Item No: R2 Recommendation to Council
Subject: **PLANNING PROPOSAL FOR 374 AND 376-382 NEW SOUTH HEAD ROAD, DOUBLE BAY (SC2873)**
Author: Brendan Metcalfe, Strategic Planner
Approvers: Chris Bluett, Manager - Strategic Planning
Allan Coker, Director - Planning & Development
File No: 15/82753
Reason for Report: To report on the request for a planning proposal prepared by Eeles Trelease Pty Ltd Architects, Tony Moody, Consultant Planner and Hill Thalys Architecture + Urban Planning on behalf of the land owner Fivex Pty Ltd.

In June 2015 a request for a planning proposal (hereafter called the planning proposal) was submitted to Council by Eeles Trelease Pty Ltd Architects in association with Tony Moody, Consultant Planner and Hill Thalys Architecture + Urban Planning Pty Ltd on behalf of the owner Fivex Pty Ltd (**Annexure 1**). The planning proposal would facilitate a seven storey mixed use development at 374 and 376-382 New South Head Road, Double Bay (the site) which comprises Lot B in DP 162458 and Lot 11 in DP 608859.

Figure 10: Proponent's concept - Knox Street elevation

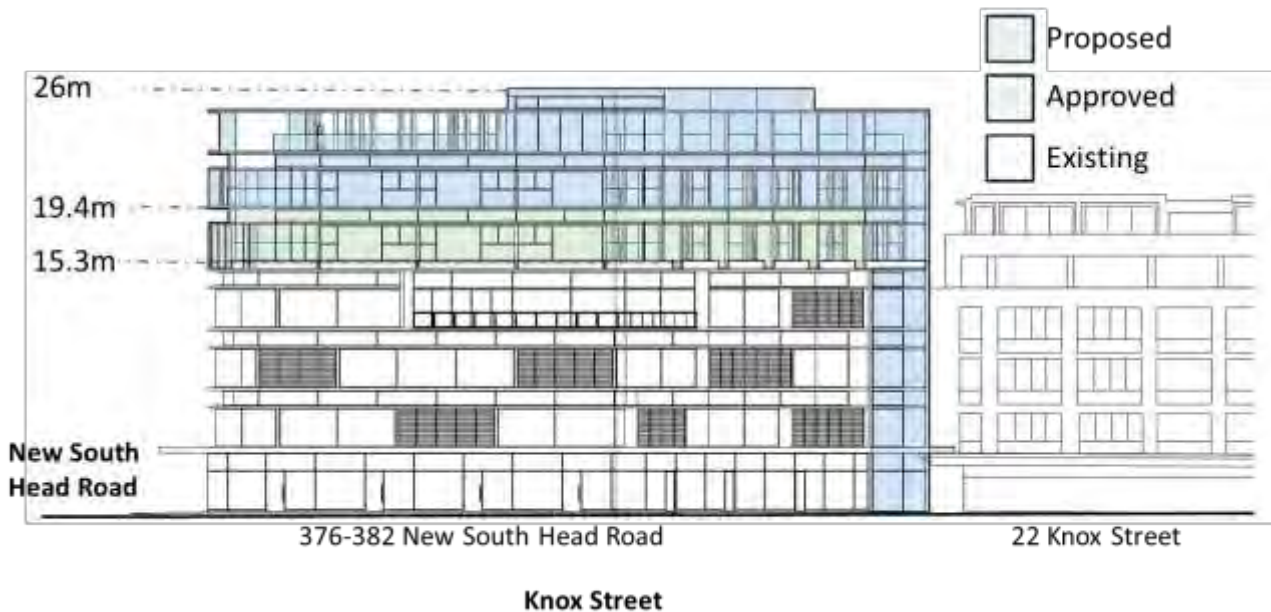
The model in Figure 11 above shows that the requested 26m (7 storeys) height limit is inconsistent with the desired future character of the location. The model shows the maximum future built form on the north and south side of New South Head Road under Council's planning controls and what is requested for the subject site.

The requested height is an increase of 77% on the current controls that apply to the site and northern side of New South Head Road. The requested control would allow a building which is two storeys and 43% higher than the 18.1m (5 storeys) applying to the south side of New South Head Road. More broadly, the 3D model demonstrates that the requested height is inconsistent with the maximum building height of 18.1m (5 storeys) permitted in the Double Bay Centre. In this context, it cannot be concluded that the proponent's requested controls will result in a built form that is compatible with the Double Bay Centre.

Proponent's shadow modelling of the concept submitted with the planning proposal on 21 June - Figure 12 (left): 12:00pm and Figure 13 (right) 1:00pm

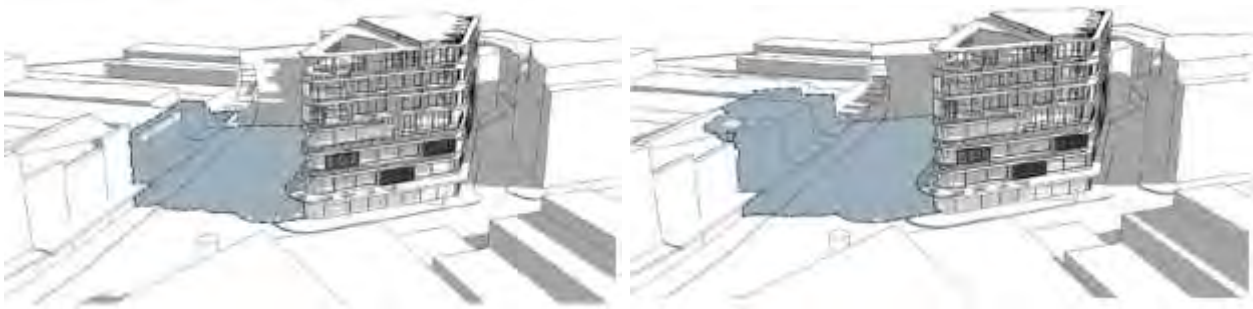
As the shadow diagrams in Figures 12 to 15 above show, the planning proposal will not preserve solar access to the south side of New South Head Road between 12 noon and 2pm on June 21. Staff have verified the proponent's shadow modelling and identified that part of the southern side of New South Head Road opposite the site will be in shadow from 10am on 21 June onwards.

Proponent's shadow modelling of the concept and submitted with the planning proposal on 21 June – Figure 16 (left): 12:00pm and Figure 17 (right): 3:00pm

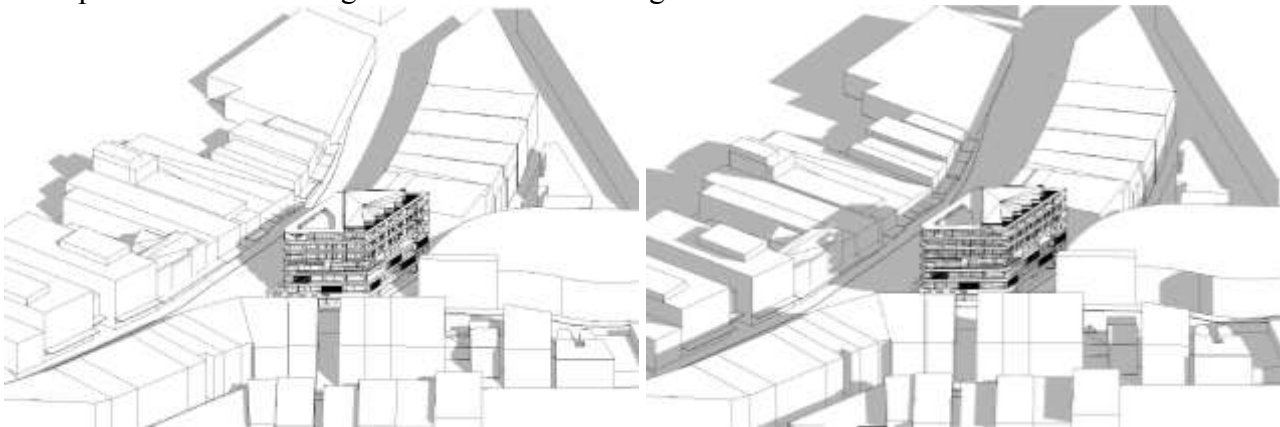
This modelling shows that at 3pm, buildings constructed to a height of 14.7m would completely overshadow the footpath and part of the buildings on the southern side of New South Head Road. Examples of this modelling are shown below in Figures 16 and 17.

Figure 18: Section of proponent's concept and separation distances

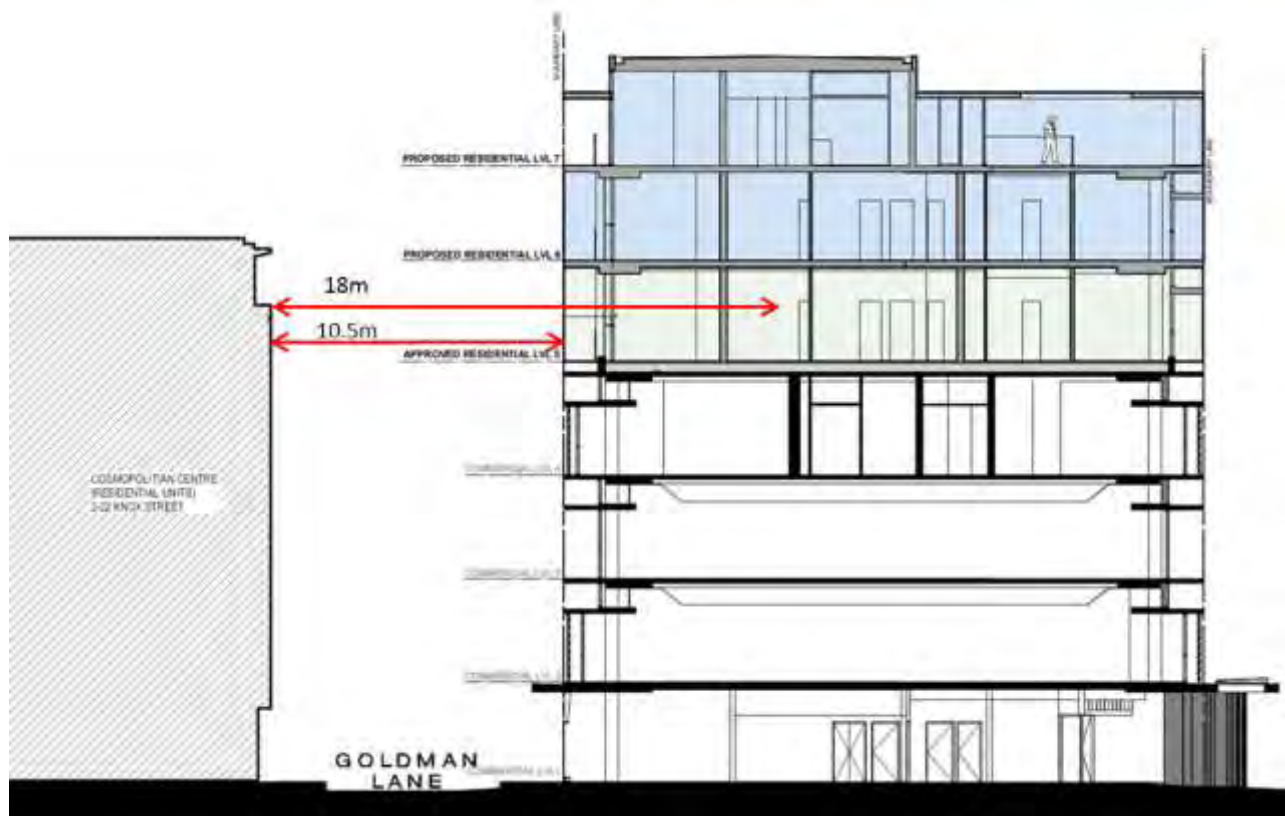
Figure 18 below shows the concept with balconies within 10.5m of the Cosmopolitan Centre and windows from primary living areas within 12m of the Cosmopolitan Centre. The separation distances are well below the 18m building separation identified in the Apartment Design Guide.

The planning proposal and proponent's concept do not minimise the impacts of new development on the privacy of 2-22 Knox Street by providing building separation that is consistent with the Apartment Design Guide. For this reason, the planning proposal is inconsistent with objective (d) of clause 4.3 *Height of Buildings*.
